**REQUEST FOR PROPOSAL**  
**FOR**  
**SAN JUAN BAUTISTA TO HOLLISTER**  
**SANITARY SEWER FORCE MAIN**

**ADDENDUM NO. 1**

**Connection Alignment  
Key Map**

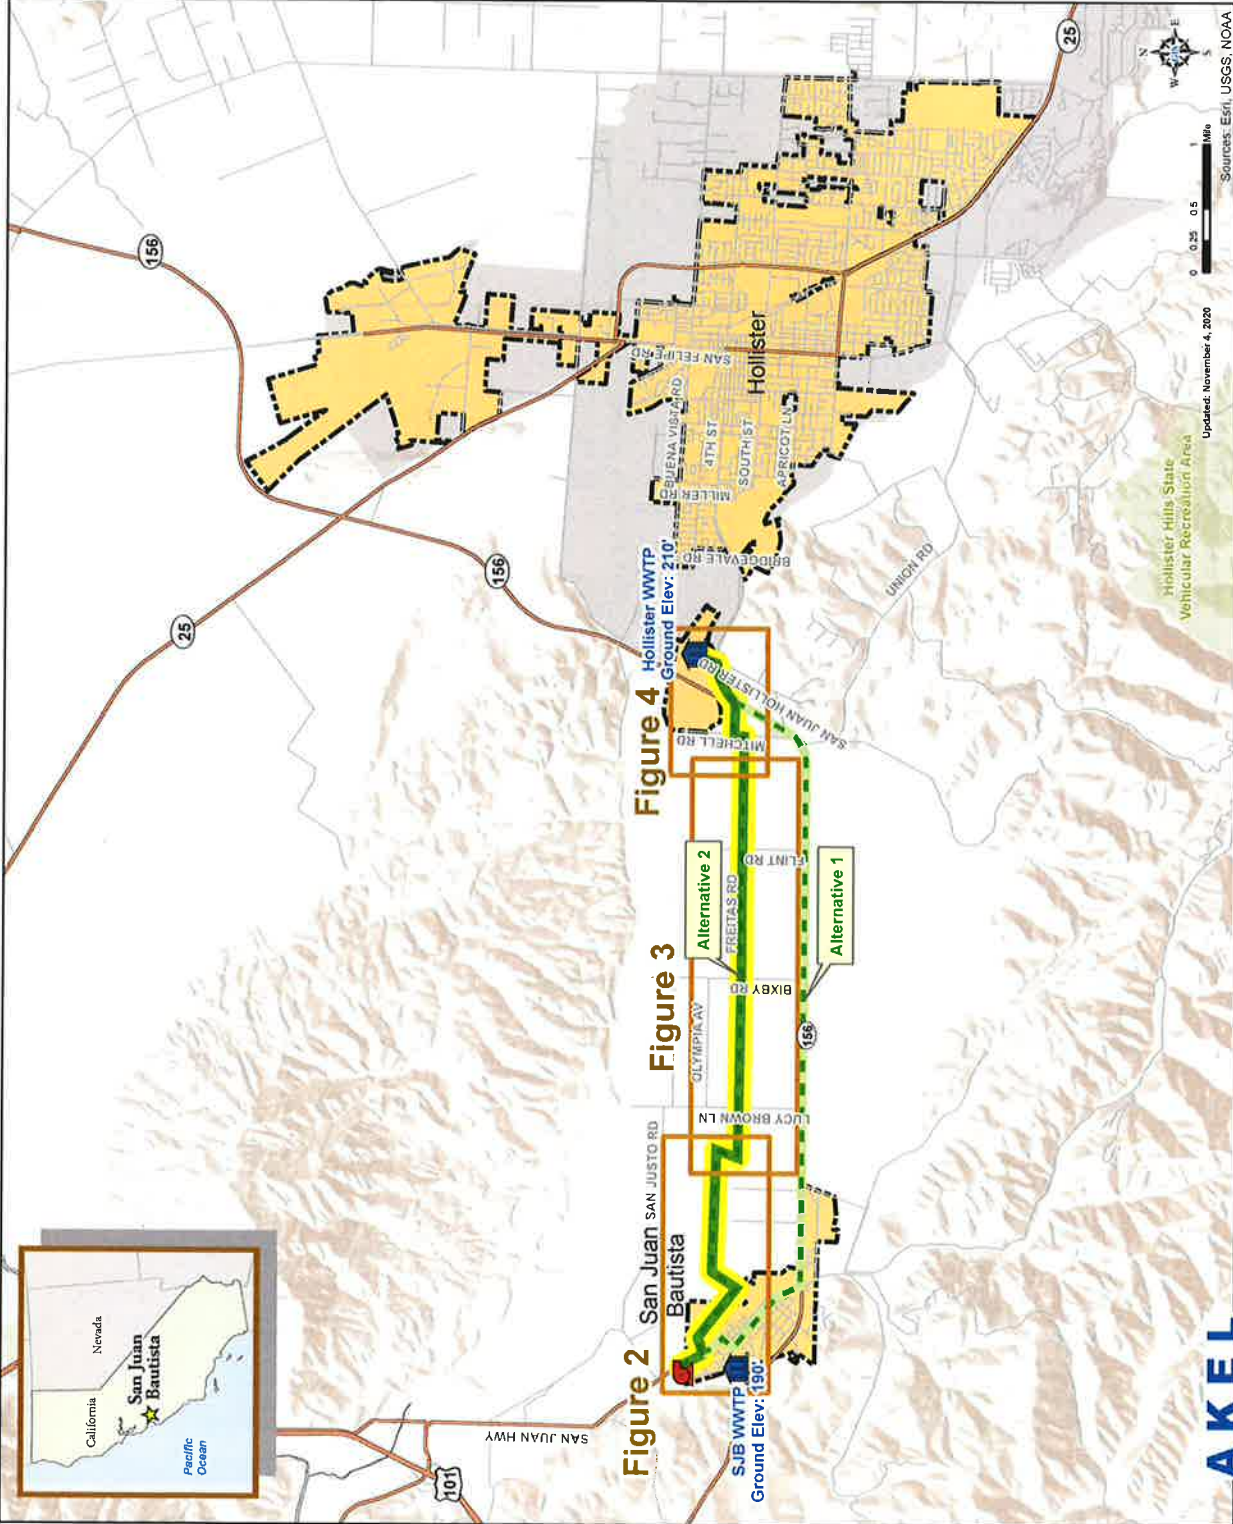
Has the City selected an Alternative presented on "Attachment E – Location Map"?

The City of San Juan Bautista has selected "Alternative 2" as the proposed alignment for the San Juan Bautista to Hollister Sanitary Sewer Force Main. (Alternative 2 is attached)
